9 St. Martins Almshouses
NW1 0BD
Basement Impact Assessment
Audit

For
London Borough of Camden

Project Number: 12466-97
Revision: D2

November 2017

No. 8 St. Martin's Almshouses– Potential Damage Calculations in Stiff Clay

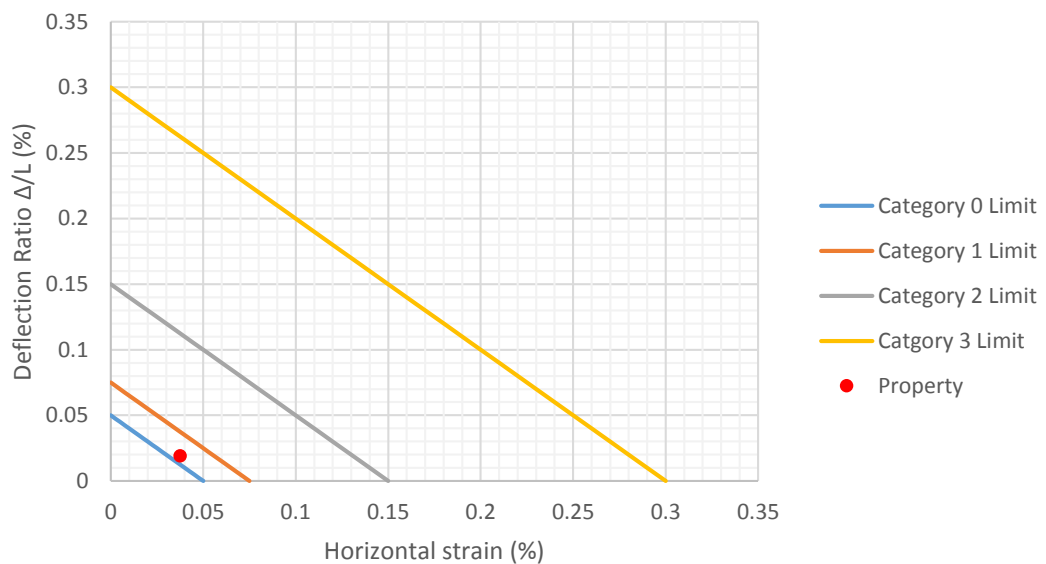
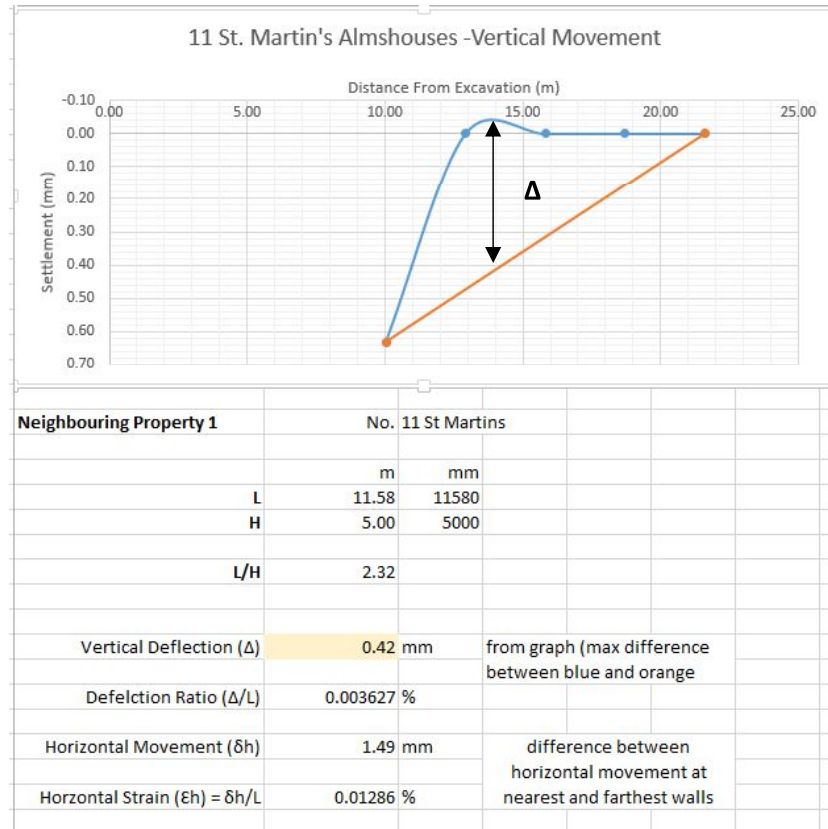
- 4.13. The revised GMA discusses both vertical and horizontal movements due to underpinning. Predicted movements are within the range to be expected for underpinning provided there is good control of workmanship. The maximum predicted damage category is Burland Category 1, which could potentially occur to No. 8 St Martins Almshouses.

- 5.8. The GMA has been revised and reissued and is accepted. Category 1 damage is predicted to No. 8 St Martins Almshouses.
- 5.9. It is accepted that the impact on ground water flows will be minimal, given the shallow depth of perched groundwater. However ground water monitoring is recommended to continue until construction.

In relation to the use of C580. The stiffness of the wall will render the top 1m of so of the soils present insignificant with respect to movement. Despite being described as Head Deposits the SPTs from 2.00 - 3.00m were 15 - 18 "N" Blow Counts, therefore stiff. Therefore the use of the C580 stiff clay graphs is deemed appropriate. Aftger all they are based on basements in London, which this is also. At the time of issue of our report C760 had only just been issued and i dont think anyone had updated their systems, even Campbell Reith. Seems a bit unfair to judge us on a document which was'nt really available at the time if issue. We have used the best tool available at the time.
